CHANGE ORDER

Project: Woodland High School Project No.: 1119.00-12
 Architect: McGranahan Architects Change Order No.: 5
 Contractor: Skanska USA Building, Inc. Date: April 14, 2014

Reference	Amount
CCD 006R1 Service Yard Utilities (COR#43)	\$19,237.00
CCD 010 Add Camber to Beams (COR#59)	\$1,083.00
COP 009R1 Power Revisions to Stage Curtain and Operable Partition (COR#41)	\$1,516.00
COP 010 Thickened Edge Slab at the Gym and Aux Gym (COR#37)	(\$1,170.00)
COP 013 Rack and Panel Move at the IDF Room (COR#44)	\$15,077.00
COR 050 RFI#140 - Brace Frame Footing	\$342.00
COR 053 RFI#136 CMU Reinforcement	\$2,244.00
COR 054 RFI #125 Sanitary Sewer Mofications	\$1,480.00
COR 057 RFI#157 Fire Protection Line at Service Yard Door	\$1,283.00
COR 058 RFI#135 Additional Joist Loading North and South Classrooms	\$8,529.00

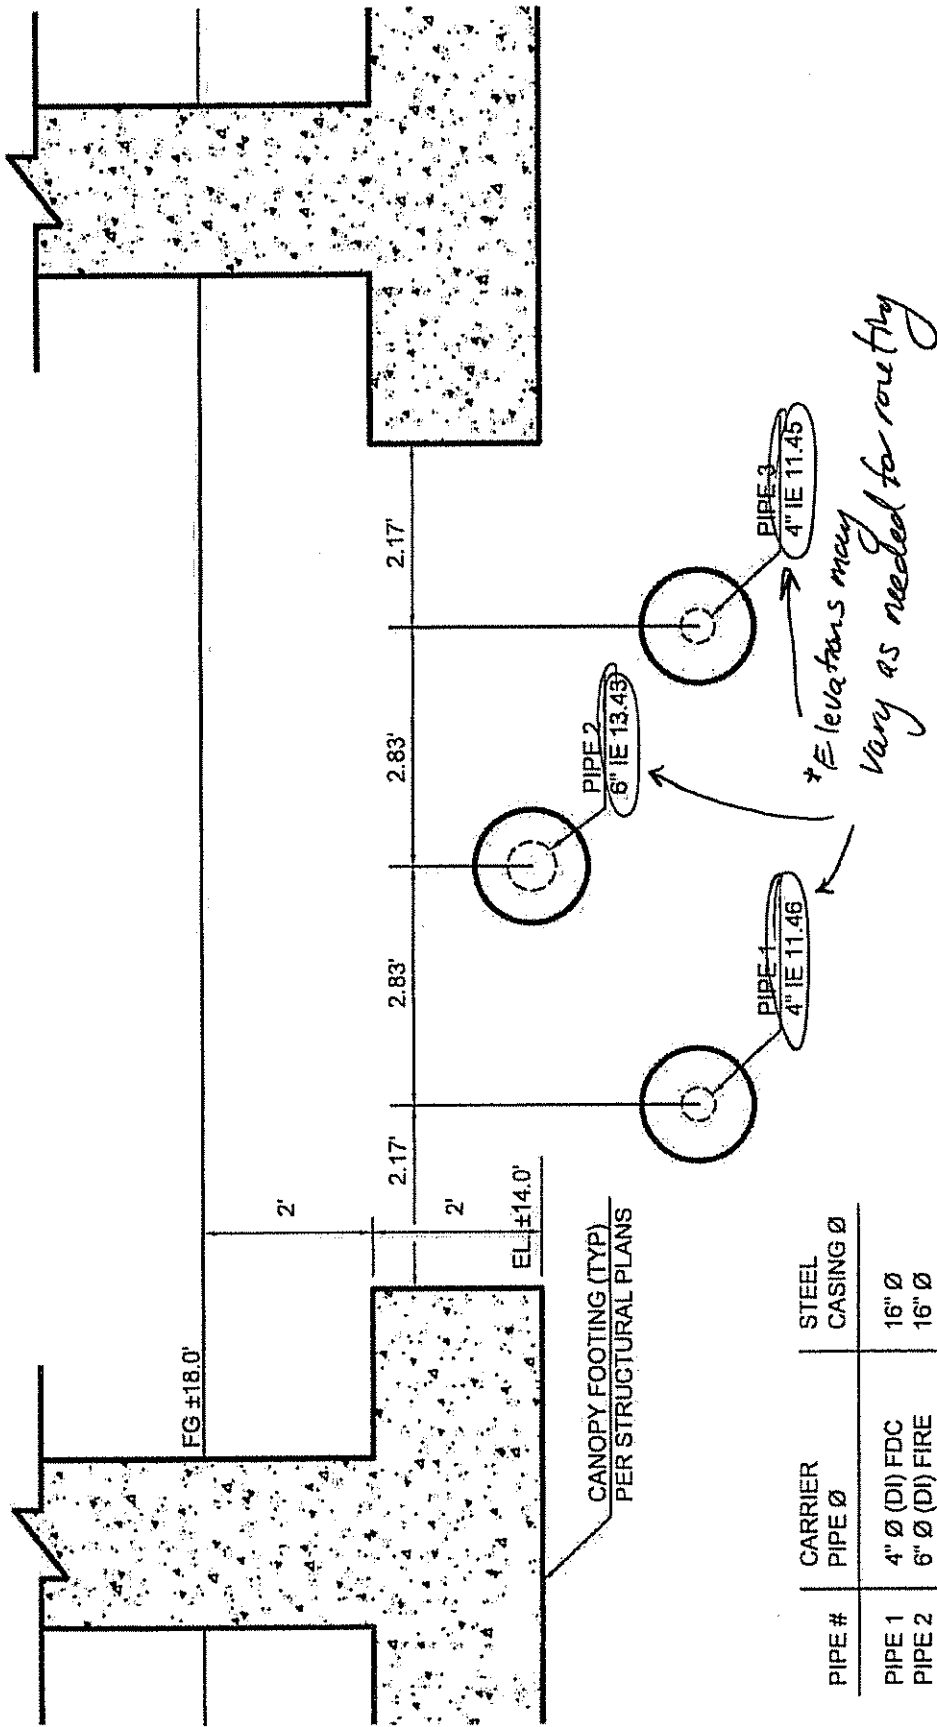
Reference C6.07 and S2.15.

The water sewer lines appear to conflict with the canopy spread footings in the service yard area. Please provide a revised route to avoid the footing or revised elevation of the footing so the lines can pass under the footings.

Please advise.

The utility lines to be revised per attached sketches CSK-033, CSK-034, AND CSK-035.

WOODLAND HIGH SCHOOL	1119.000 McGRANAHAN architects	NTS	F 253 2 T 253 3 T 253 3
TITLE: WATER LINES AT CANOPY FOOTING - ELEVATION VIEW			CSK-034
REFERENCE: C6.07			
SCALE: NTS			
ISSUED FOR: RF1 #106			
DATE: MARCH 7, 2014			REVISED: MPW
			DRAWN BY: EAP

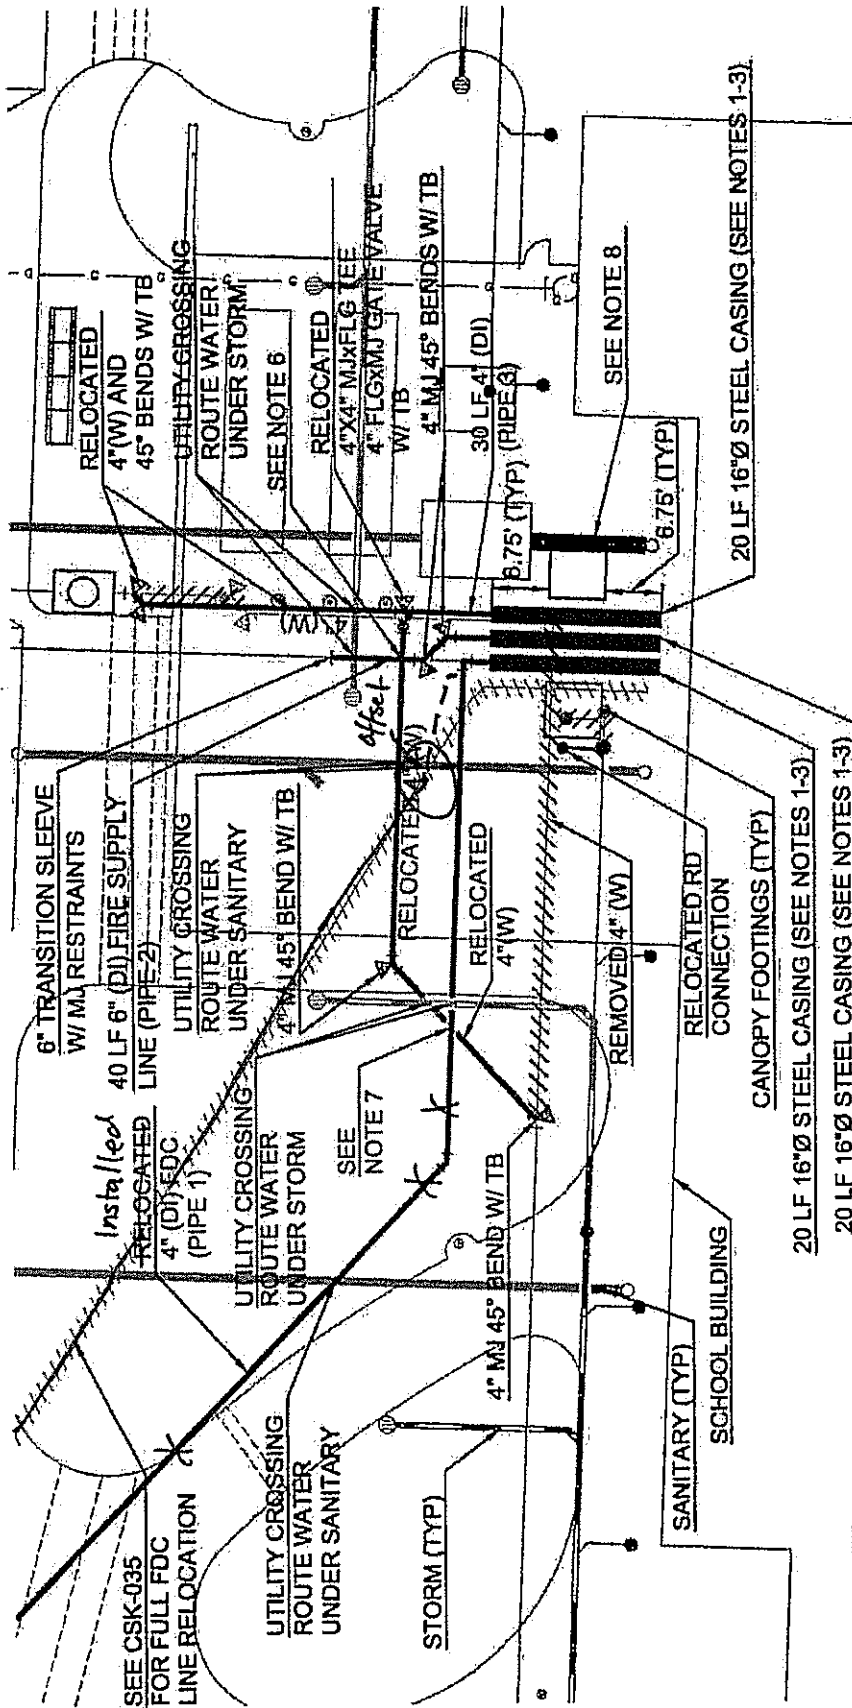
- NOTES:
- GEOGRID TO BE REPAIRED WHEN GEOGRID IS REQUIRED TO BE CUT TO PLACE PIPE.
 - STEEL CASING PER CITY OF WOODLAND STD DET W-16 SHEET C9.20

TITLE: FDC LINE RELOCATION
 REFERENCE: C6.07
 SCALE: 1"=20'
 ISSUED FOR: RFI #106
 DATE: MARCH 7, 2014

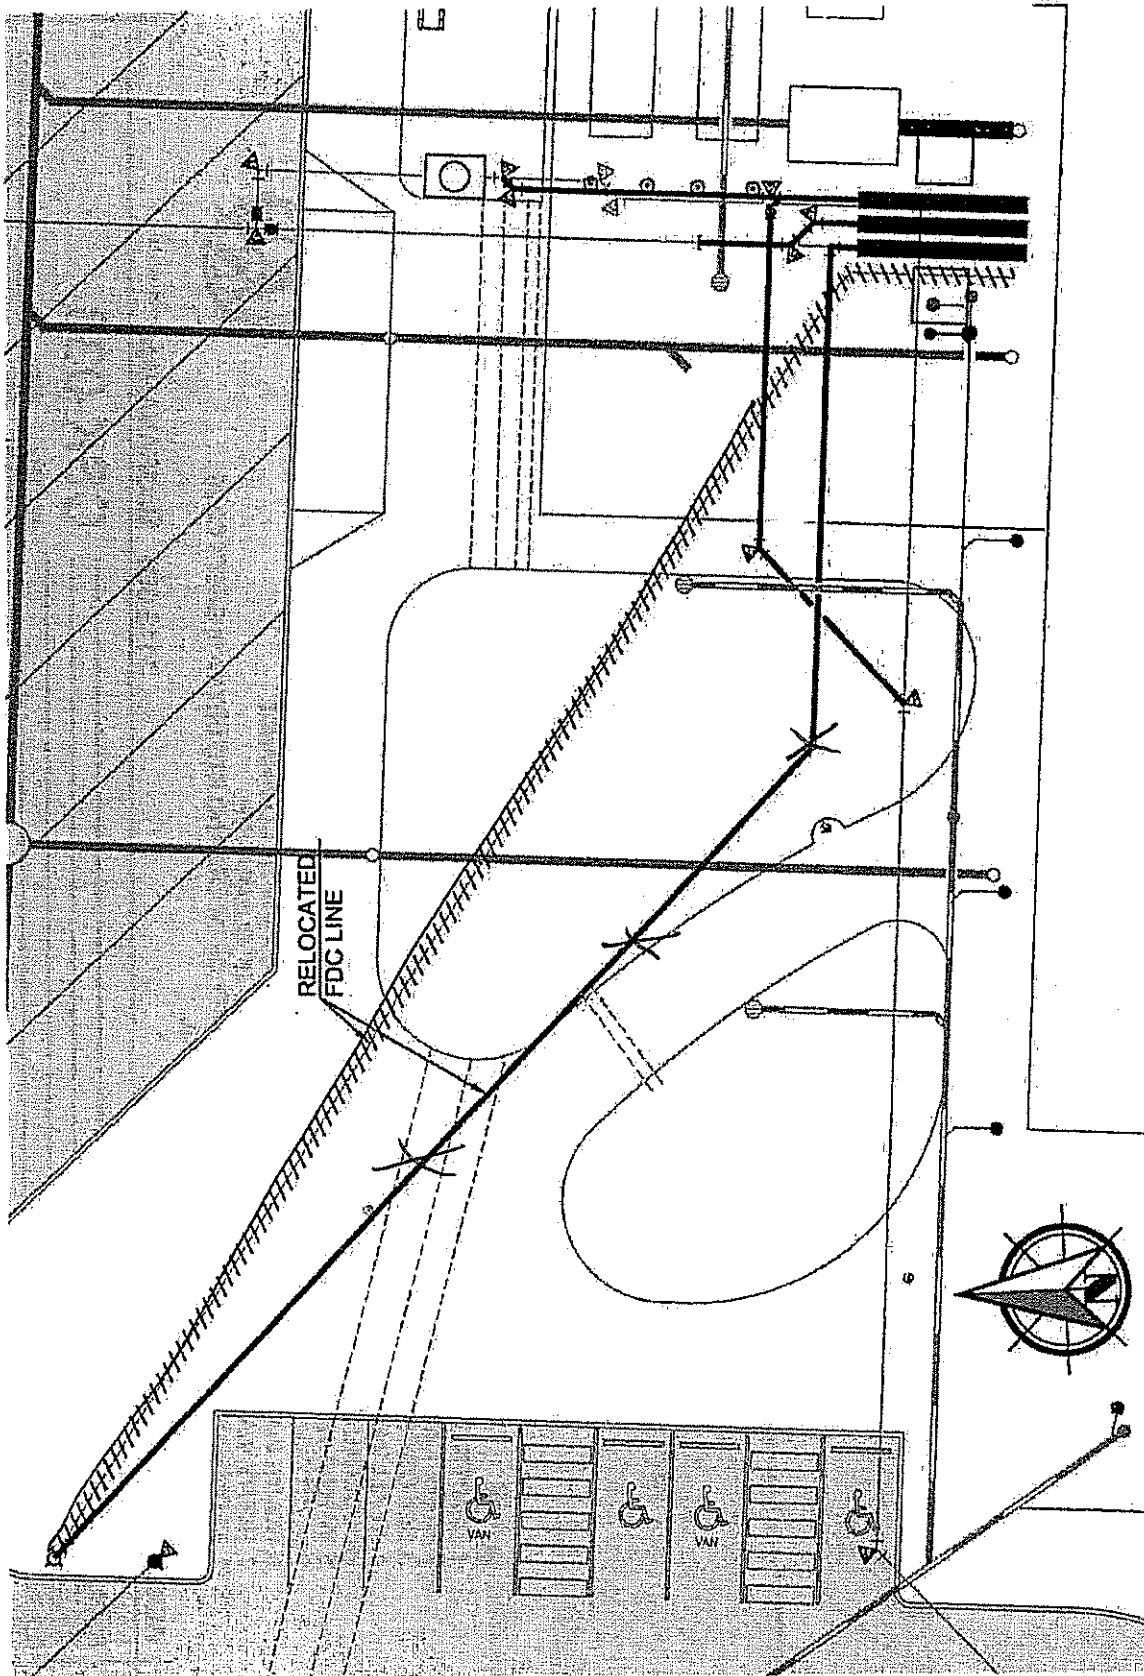
1. CENTER STEEL CASING ON FOOTING PER PLAN DIMENSIONS
2. STEEL CASING PER CITY OF WOODLAND STD DET W-16 SHEET C9.20
3. SEE CSK-034 FOR WATER LINES AT CANOPY FOOTING - ELEVATION VIEW
4. AT ALL WATER AND SANITARY CROSSINGS, MAINTAIN A MIN CLEARANCE PER CITY OF WOODLAND STD DET W-20 SHEET C9.20
5. WHERE WATER CROSSES UNDER SEWER PROVIDE CASING CENTERED ON CROSSING PER CITY OF WOODLAND STD DET W-16 SHEET C9.20
6. ROUTE WATER UNDER FIRE SUPPLY LINE. MAINTAIN MIN 18" CLEARANCE.
7. ROUTE WATER UNDER FDC LINE. MAINTAIN MIN 18" CLEARANCE.
8. PROVIDE STEEL CASING ON SANITARY PER CITY OF WOODLAND STD DET W-16 SHEET C9.20. SEE STRUCTURAL PLANS FOR FOOTING DETAIL.

TITLE: PARTIAL POWER PLAN -COMMONS
 REFERENCE: E3.12
 SCALE: 1/8" = 1'-0"
 ISSUED FOR: COP-009
 DATE: 02/07/14

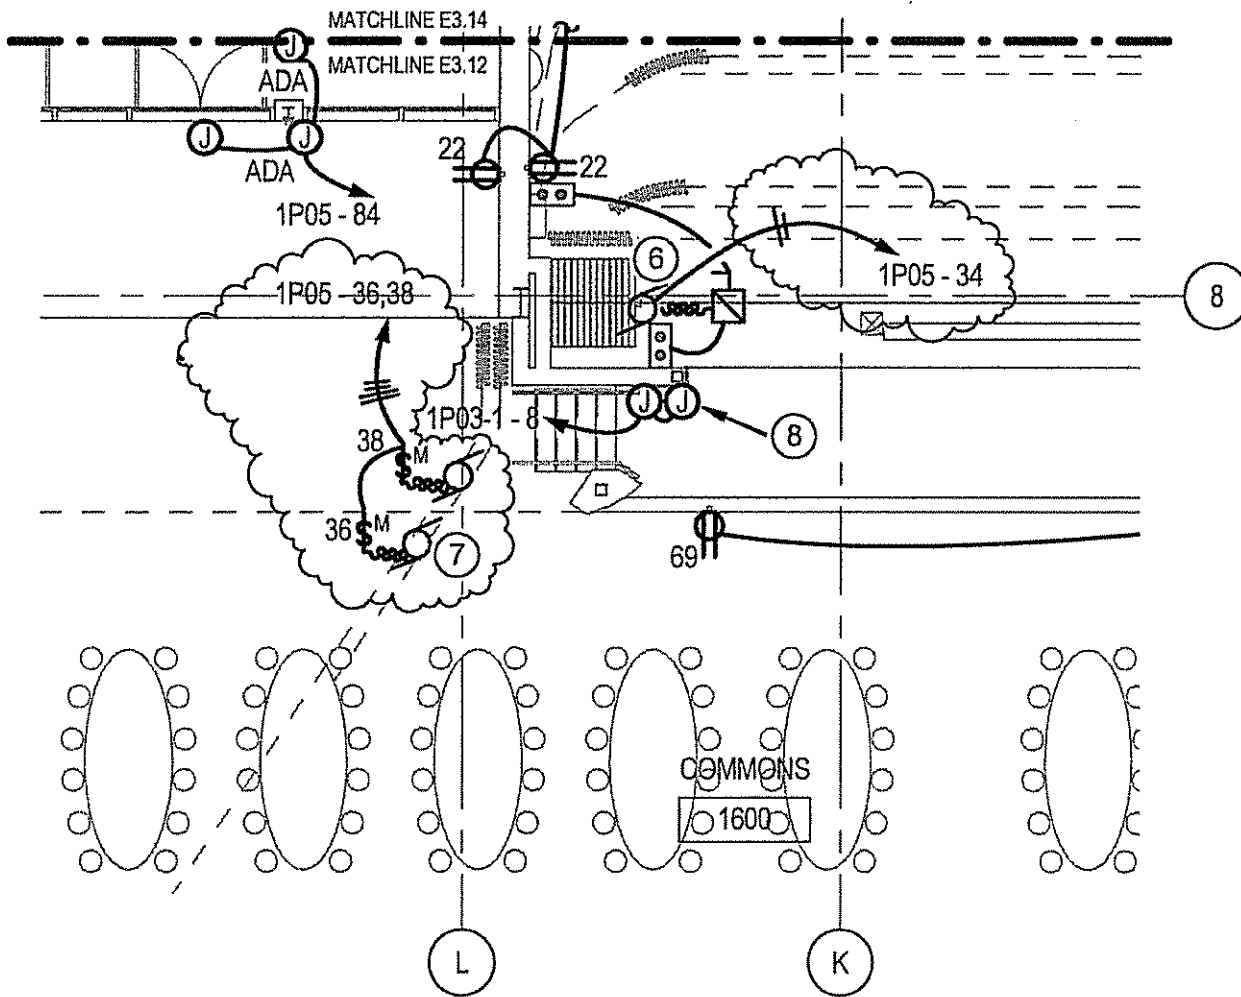
- 1.) Revise Construction Note 6 as shown.
- 2.) Add Construction Note 7 for additional connection to Side Stage Curtains.
- 3.) Add Construction Note 8 to clarify connection to projection screen. There are no modifications to the projection screen scope of work.
- 4.) Revise the 3P-20A circuit breaker at 1P05-34,36,38 to be (3) 1P-20A circuit breakers.
- 5.) Revise the circuit connection and provide (2) motor rated disconnect switches for (2) Side Stage Curtain motors, rated 1/3HP at 120V.

- ⑥ PROVIDE CONNECTION TO THE FOLDING PARTITION. COORDINATE EXACT LOCATION AND REQUIREMENTS WITH GC AND INSTALLER PRIOR TO ROUGH-IN.
- ⑦ PROVIDE CONNECTION TO SIDE STAGE CURTAIN. COORDINATE EXACT REQUIREMENTS AND CONTROL LOCATIONS WITH GC AND ARCHITECT PRIOR TO ROUGH-IN.
- ⑧ PROVIDE CONNECTION TO MOTORIZED PROJECTION SCREEN AND ROUGH-IN FOR SCREEN CONTROLS. COORDINATE EXACT LOCATION AND CONNECTION REQUIREMENTS WITH GC AND ARCHITECT PRIOR TO ROUGH-IN.

PARTIAL POWER PLAN - MECHANICAL 2700

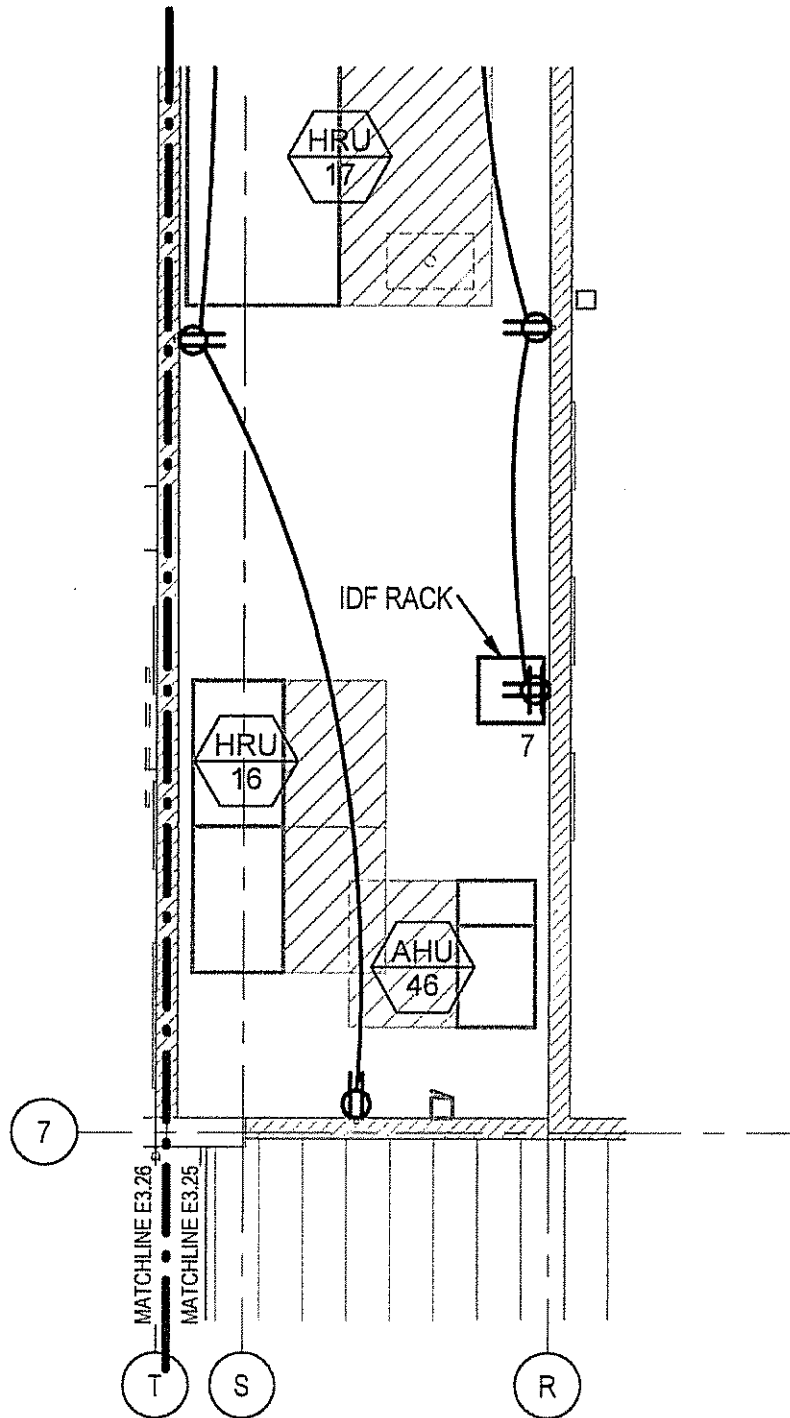
1. Provide floor to structure vertical unistrut on the East face of the chain link fence, South of the gate.
2. Relocate Panel 1P01, the SPD and fourplex receptacle to the communications backboard secured to the unistrut supports.
3. Revise the duplex receptacle on the North wall of PE Storage 1709 to be a fourplex and relocate as shown for the Aux. Gym Sound System Rack.

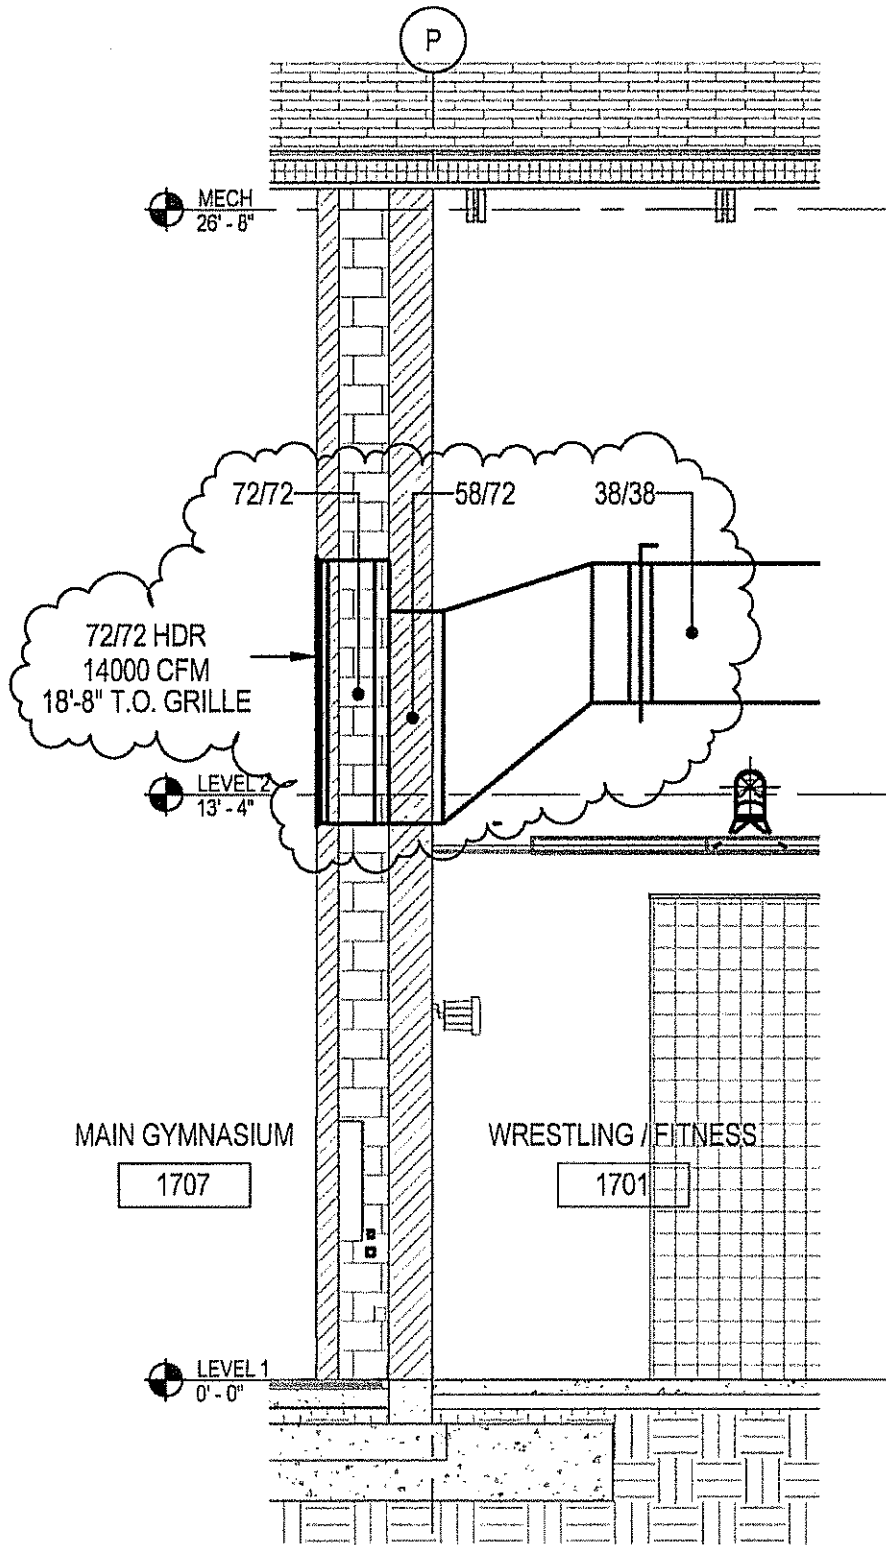
Reference sheets S7.1 and S7.2 and returned submittal 033000.012.0.
1. Please confirm per the attached returned submittal 033000.012.0 that the jamb rebar as indicated shall be revised per KGA's notes to only extend to the mezzanine level and to be reduced per each specific location note.
2. Please confirm that the vertical and horizontal rebar as noted at the wall openings are required as indicated per the KGA notes on the returned submittal 033000.012.0.
